**Public Information Centre 3 Summary
Report**

Schneider and Shoemaker Creek
Naturalization Environmental
Assessment

Prepared for:
City of Kitchener

Prepared by:
Stantec Consulting Ltd.
100-300 Hagey Boulevard
Waterloo, ON
N2L 0A4

Alternative 1a: Multi-Use Trail along the South Side of Schneider Creek and East Side of Shoemaker Creek

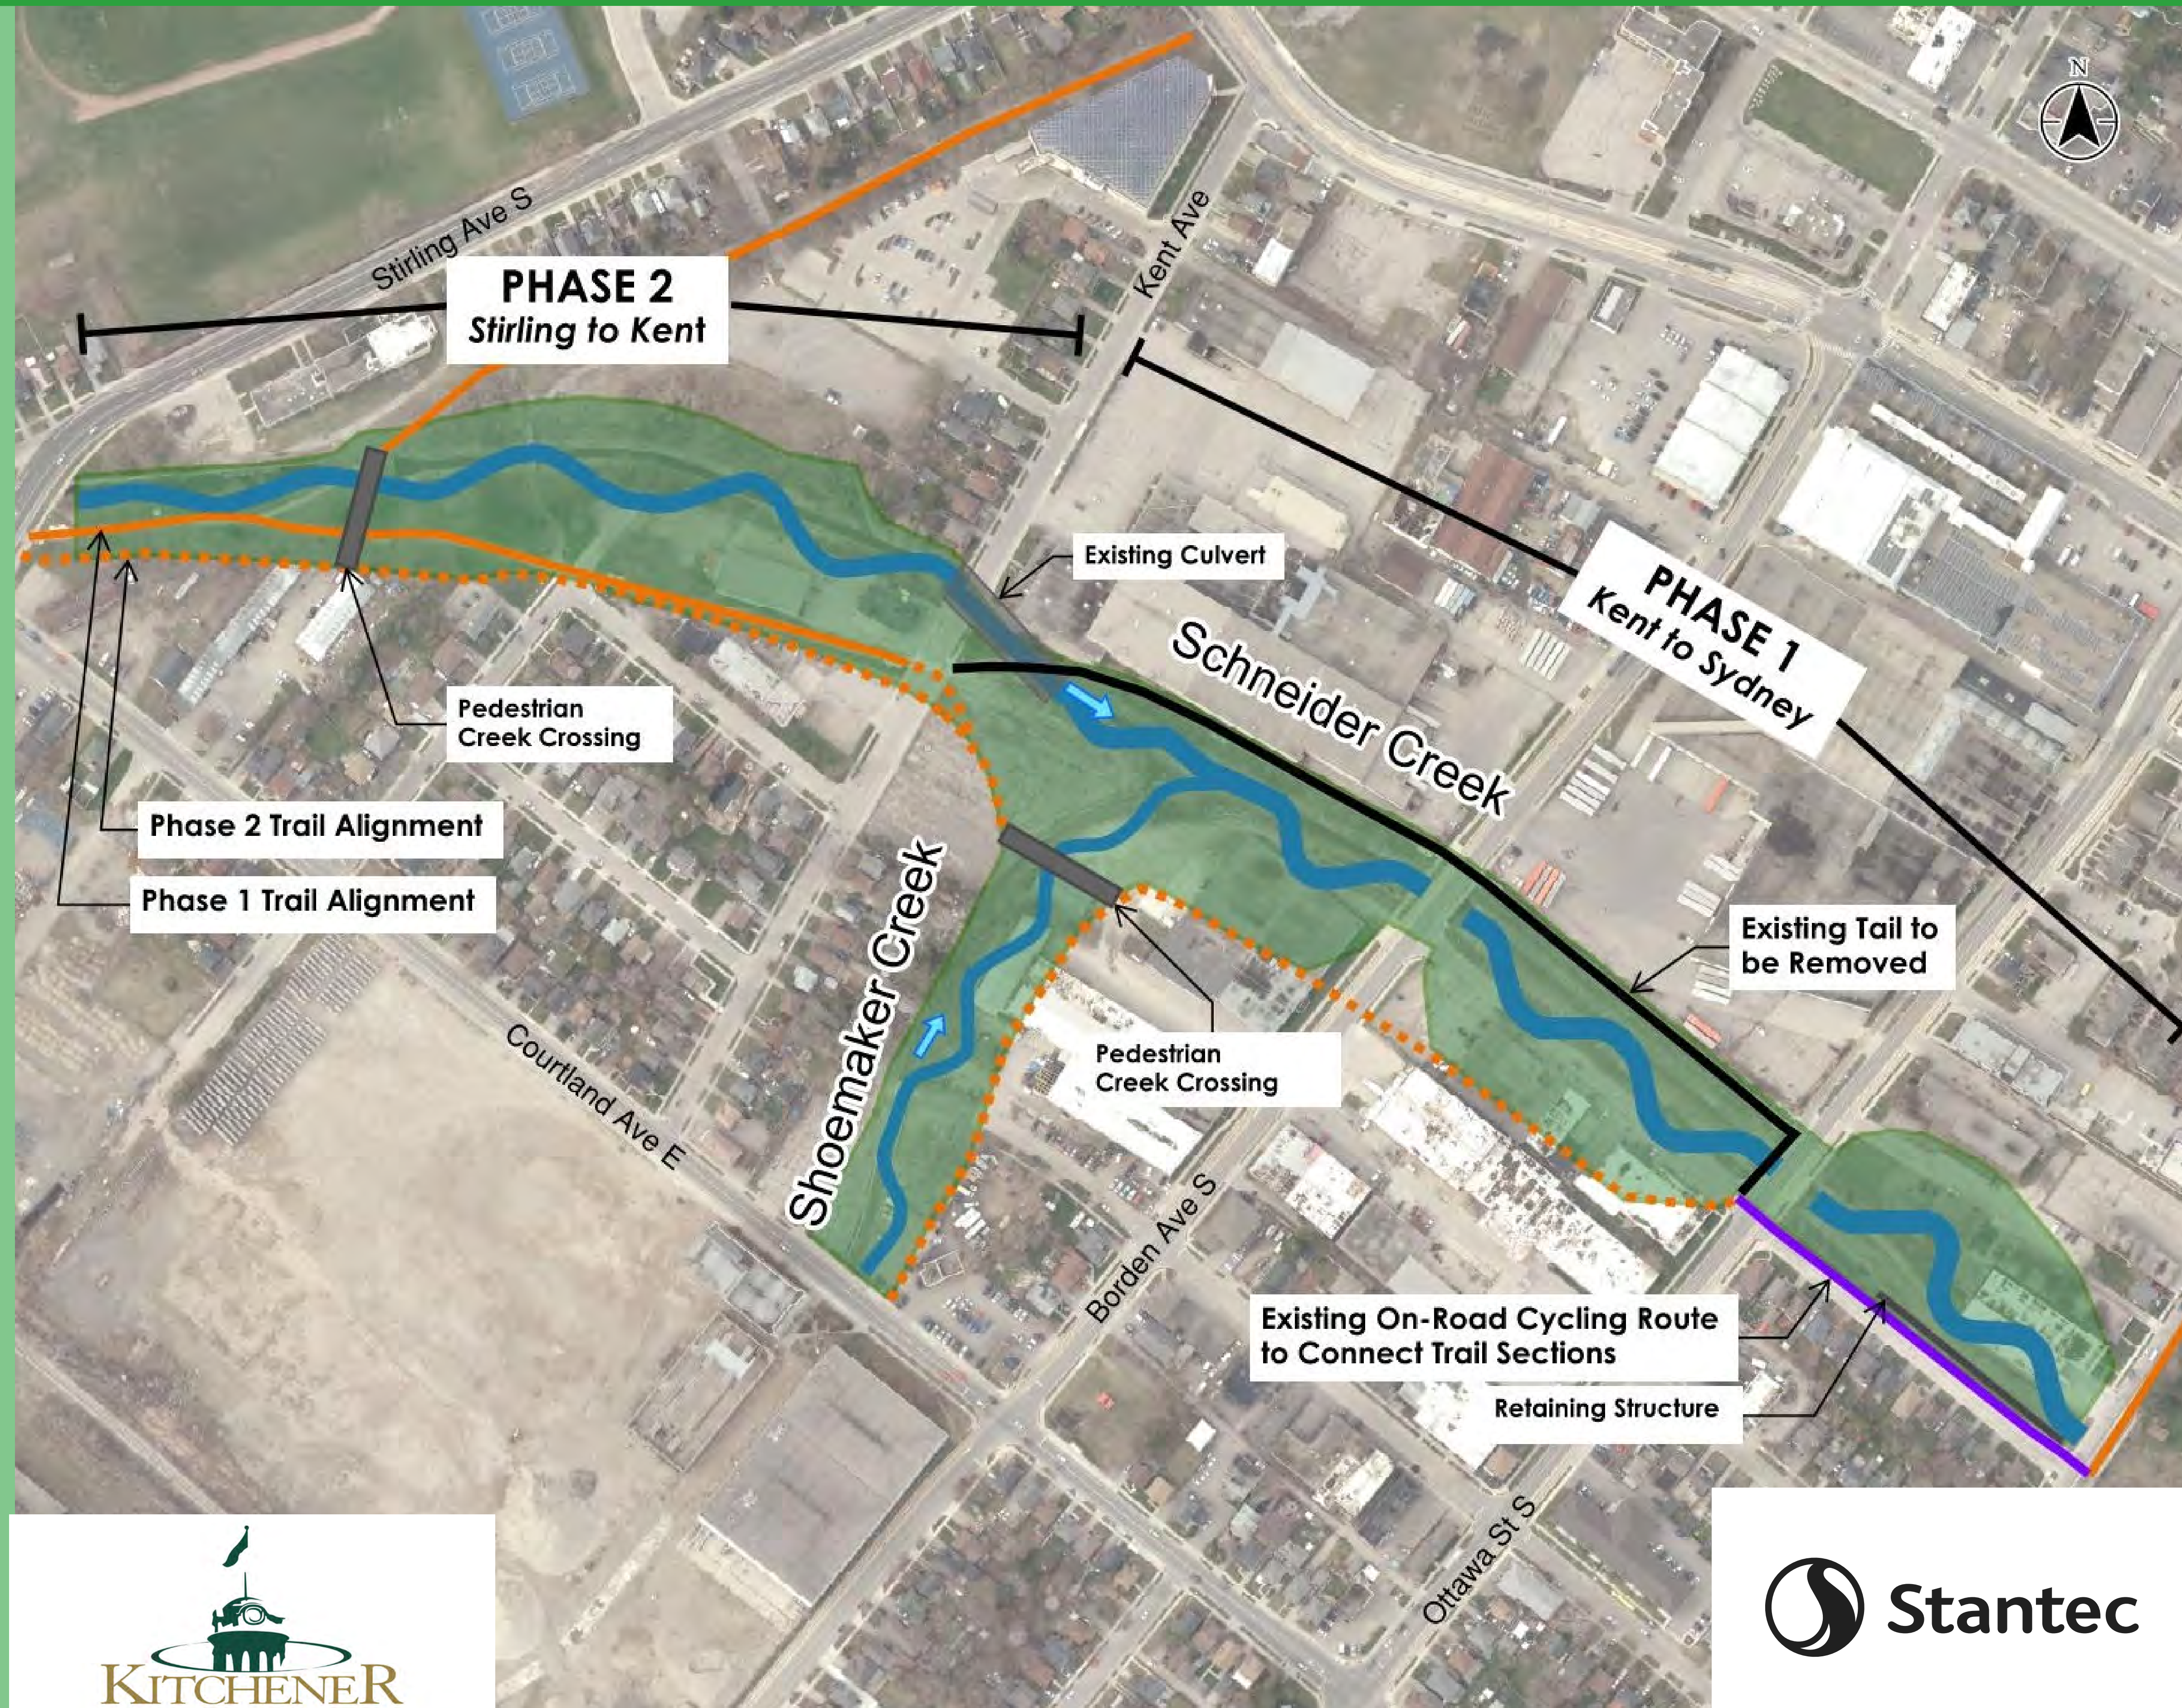
- Alternative 1a: Multi-Use Trail along the south Side of Schneider Creek and East Side of Shoemaker Creek
 - Zero votes (0) votes
 - Concerns that no trail connection is being maintained and about the on-road biking and walking section
 - Prefer not to have a pedestrian crossing over Shoemaker Creek and lack of trail connection to Sydney Street
 - A straight-forward path route is appreciated
 - Maximize re-naturalized areas
 - Makes use of roads running parallel and perpendicular to the creek to provide regions of interaction
 - Opens up future re-naturalization of regions north of the existing trail, where the floodplain exists
 - No access to the creek limits interaction with nature
 - Concerns around cost due to removing the existing trail
- Suggestions for safety measures. Please use heavily marked signage for single-line cycling and speed limits.

Alternative 2b: Naturalized Creek with Multi-Use Trail along a combination of the North and South side of Schneider Creek and West side of Shoemaker Creek. Added Trail Amenity Features up to three)

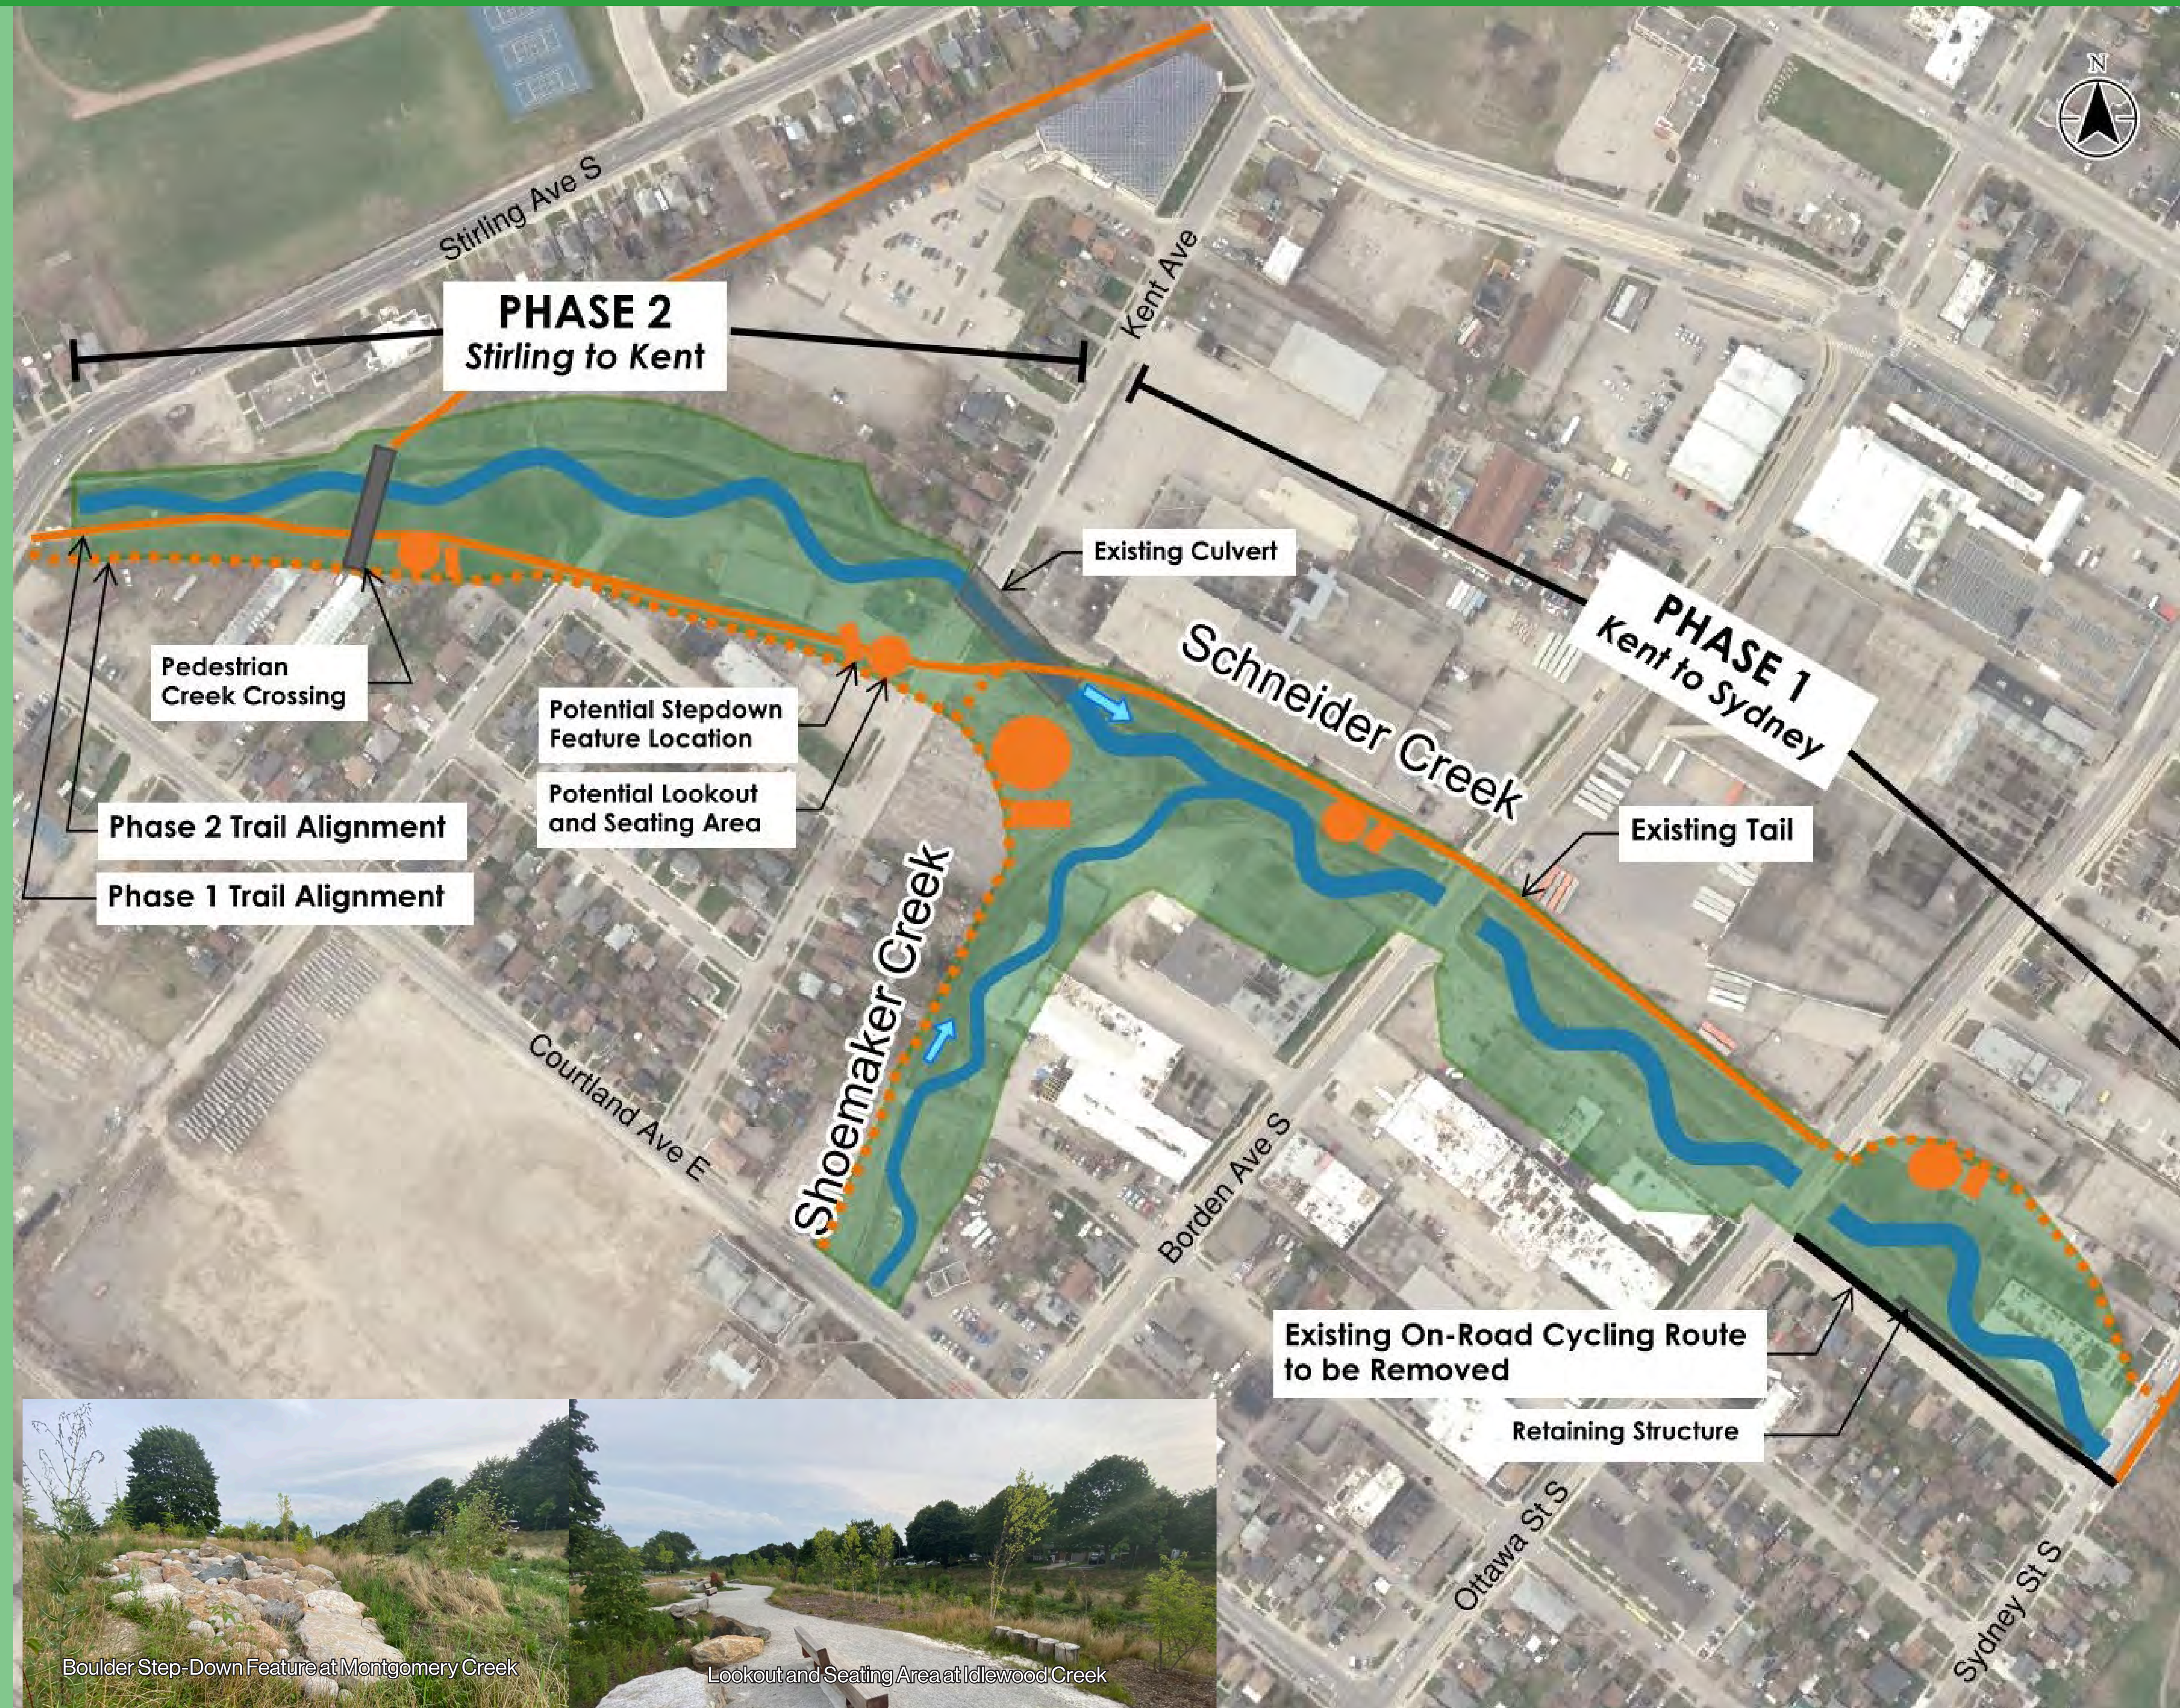
- Five (5) votes
 - Support of the new trail alignment compared to the other alternatives
 - Strong support of amenities as long as social safety (i.e., lighting, accessibility for all) can be addressed

- To resize the culvert on Kent Ave
- A natural connection to Sydney St. S and new trail to Rockway
- Suggestion of adding playground structure to the amenity spaces

- Evenly-spaced seating area
- Suggestion of not removing the existing trail
- Request to widen the trail
- Appreciates the culverts being kept as it will reduce costs

- Using existing trail reduces costs but concerns about the net impact of floodplain management
- Appreciate the lower cost compared to Alternative 1a and the attraction to more users

- Request for a trail connection between Sydney Street and Delta Street
- Concerns around the ‘look out’ infrastructure as it could increase water velocity and increase maintenance costs. Suggestion to replace this amenity with a step-down feature

- Suggestion of adding ‘tofu rocks’ to assist with erosion control
- Suggestion to move the lookout feature to above the existing culvert
- Request for a walking tour with project team of the features

- Add additional signage to show the height of the floodplain water during a storm
- Concerns for the lack of washroom amenities

The presentation boards from PIC#3 are available on the project website. The Project Team have reviewed comments received during PIC#3. Results of consultation confirms the Preferred Alternative Design Concept is Alternative 2b. The next step in the Class EA process is Phase 4: Environmental Study Report. This Report will be posted to the Project website. The following field work will occur throughout 2024:
